SSD 35538829: PARRAMATTA METRO OVER STATION DEVELOPMENT

SUBMISSION

STATEMENT OF OBJECTION

Figure 2: Diagram showing the separation impact between Buildin A and the site to the west (Source, Turner Studio, 2023)

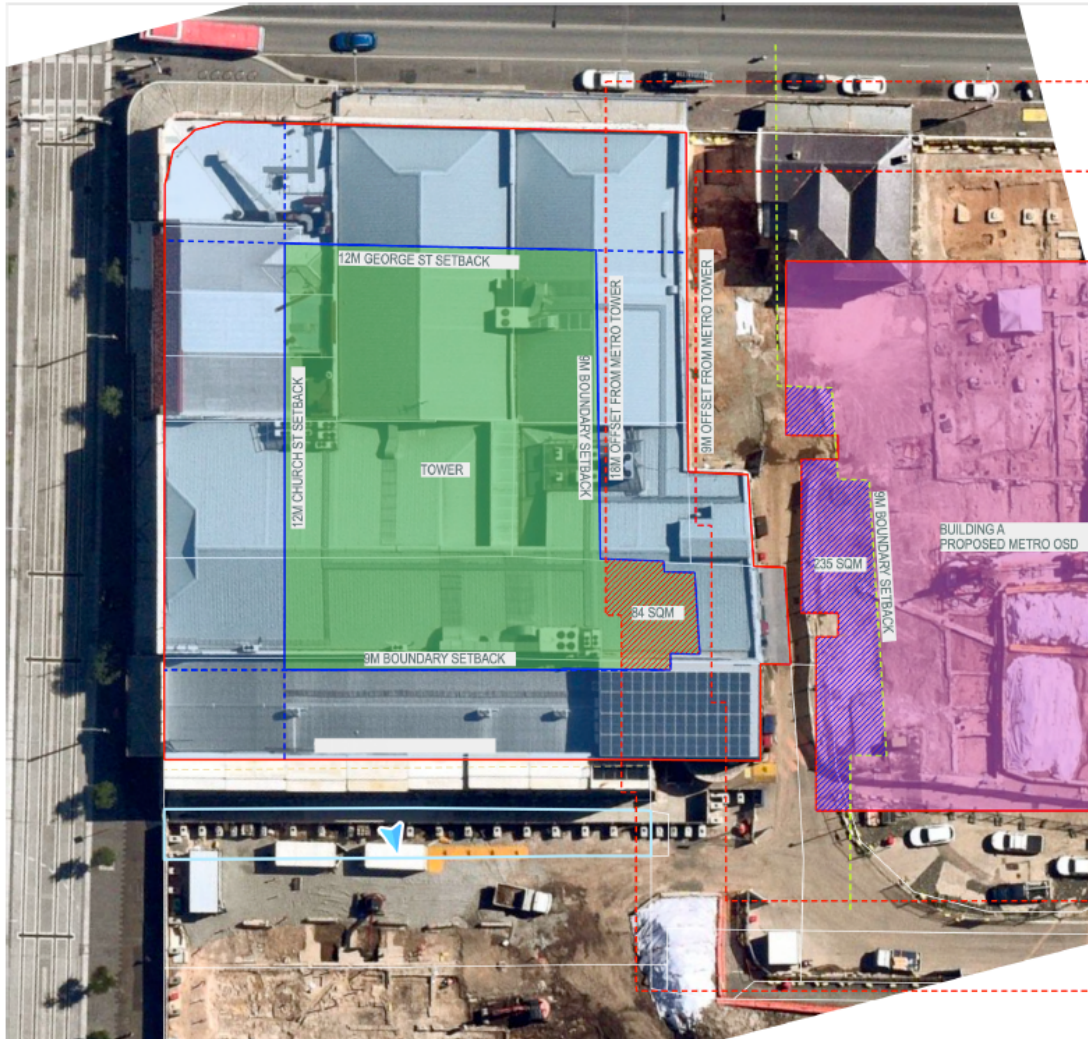
The Concept Application, however, is entirely inconsistent with the DCP separation requirements. This has been confirmed by Turner Studios, who mapped the envelopes over the Metro Site and the neighbouring properties to the west of Building A. This analysis shows that to achieve an 18 m separation, this will be applied to our clients and potential development partners' land. The impact of this change is:

- Our client will lose of at least 84 m², equivalent to 2,285 m² over the height of the building and having a significant cost implication to development feasibility.
- Sydney Metro will gain circa 235m² which, when extrapolated over the height of the building, represents a significant additional yield on metro land.

- Is inconsistent with the ADG separation objectives and requirements
- Is inconsistent with the City of Parramatta DCP minimum building separation of 18m
- Does not equally apportion the separation between Building A and the site to the west as required by the ADG and the DCP
- Places the burden of a tower being able to be viewed in the round on our client's site only

It is apparent that Parramatta Council require an 18 m setback between buildings, and without amendment, our client's development potential is significantly reduced.

- Building A be redesigned to prevent it from stealing floorspace from our client's neighbouring site.
- The floorplate of Building A be reduced to facilitate the equitable sharing of building separation of at least 9m on each respective site.
- Building A be redesigned with a smaller floorplate to fit better into its context and display a harmonious relationship with Church Street and surrounding development.
